TECHNICAL BULLETIN 20230320

SEISMO VIBRATION/TILT SENSORS

1. V3 marking on internal product label

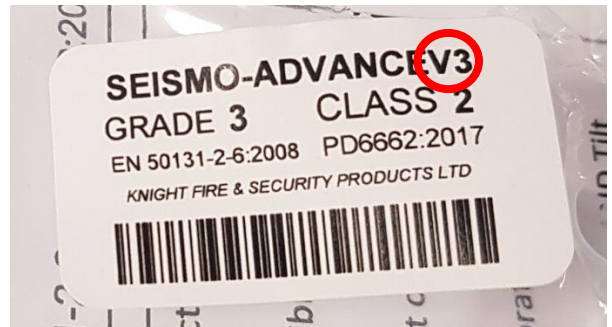
Only v3 products falling within the above serial ranges are affected. They can be identified from the small label placed on the inside of the lid (1). Larger labels on the outer packaging are also marked with v3 for this line of products (2). For products sealed in bags with these labels, it is prudent to assume they are in the scope of this bulletin if purchased prior to 20/03/2023. V3 PCBs will always have a square potentiometer (3) – older unaffected versions use a round potentiometer.

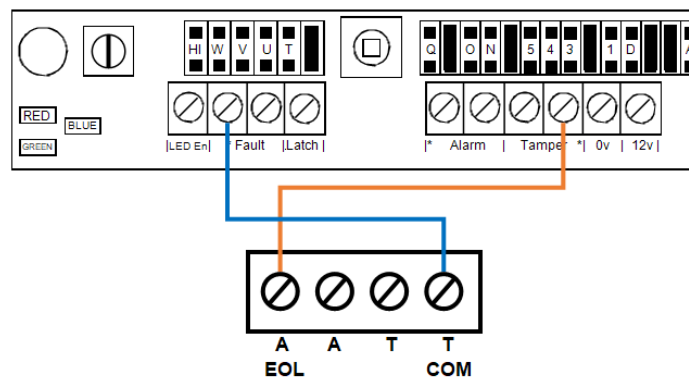
The root cause has been traced to a change to the specification of an onboard ESD protection diode - from bidirectional operation to unidirectional operation. This unidirectional ESD diode will abnormally affect the CIE reading of zone resistance if the polarity of the zone connection is reversed in respect to the diode.

Abnormal. Zone should read 2k2 secure but reads 3k5.

This issue is resolvable in situ without any need to return the product for repairs or modification. **A reversal of the zone connection wires will restore normal function if this problem is encountered.** See below examples of Pyronix TEOL (2k2/4k7/6k8) installations in both normal and abnormal states:

Normal. Zone reads 2k2 secure as expected.
